Since the approval of Westerlea View Lofts at 75 Chestnut Street, there have been modifications made that affect the approved documents. The changes were made for multiple reasons including potential owner requests, structural and code implications of approved items and reconfiguration for interior layout purposes as the project developed. The following list includes the design changes that have occurred that we plan to present at the March 13th Planning Board.

RE: Chestnut Street, Westerlea View Lofts

As requested, this letter notes the changes to the plans to bring the project into compliance with the Planning Board's Conditions of Approval. We are requesting a building Permit so the project can move forward.

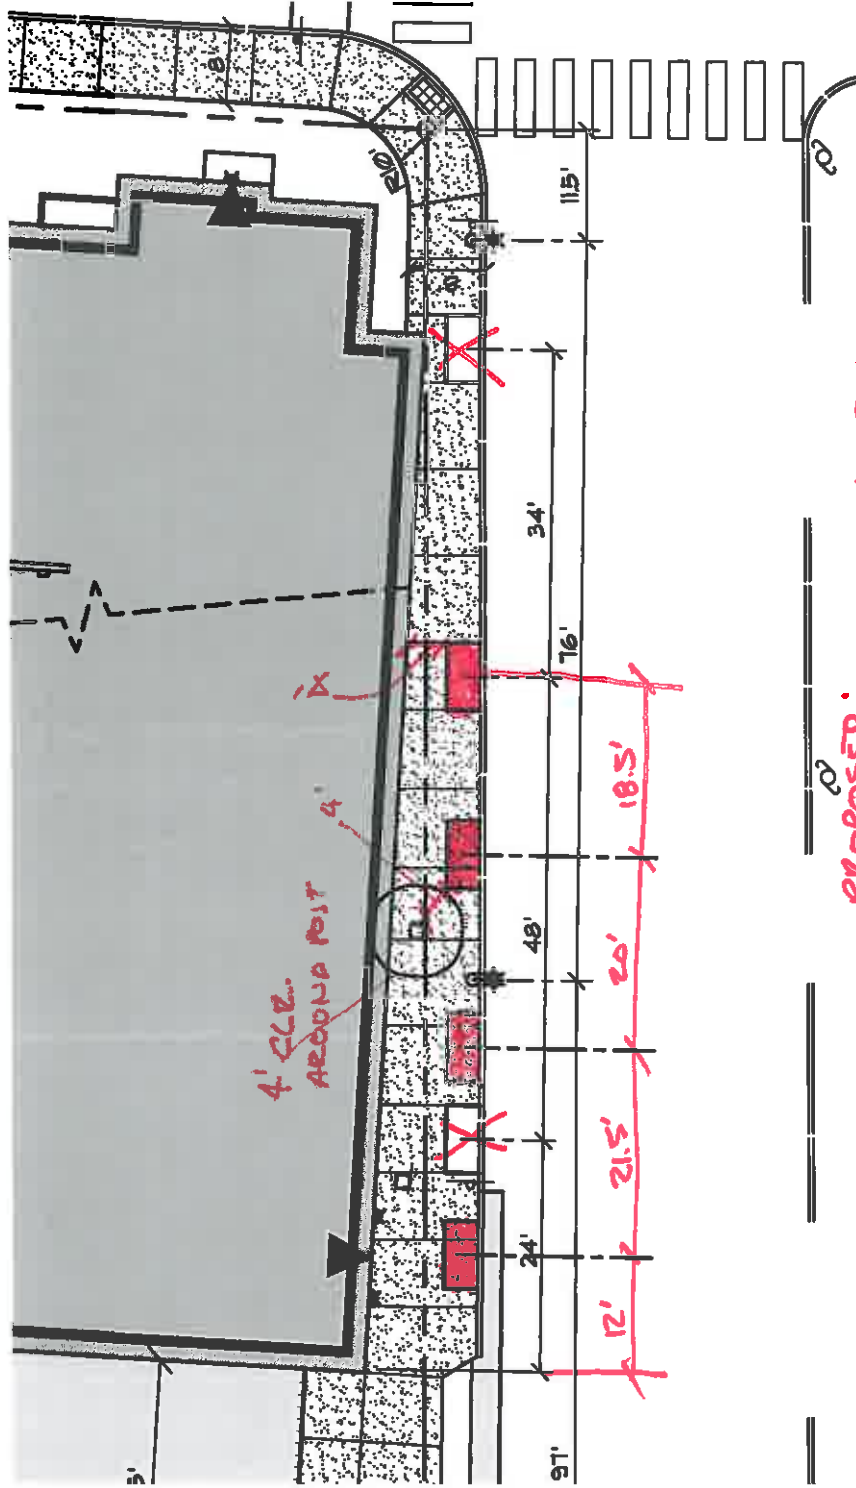
1. The building footprint has been revised responding to the Staff comments.
2. The tree wells on Chestnut Street have been revised. We have added an additional tree. The spacing has been revised to ensure that at least 4 feet of walk is available.
3. The easements and licensing have been revised to match the new building footprint.
4. The grading at the entrance door and across the entrance drive off Chestnut Street have been coordinated with the new footprint to ensure a 2% cross slope.
5. The Oxford end of the building has been modified. It includes a vent for the laundry and new plaza area.
6. The utility connections for the building have been revised to match the new utility room location.
7. Additional notes have been added at the corner of Lancaster and Chestnut to eliminate any ponding of water.

PROPOSED:
 4 TREE WELLS
 PREVIOUSLY: 3

KEEP - 1
 DELETE - 1
 RELOCATE - 1
 ADD - 2
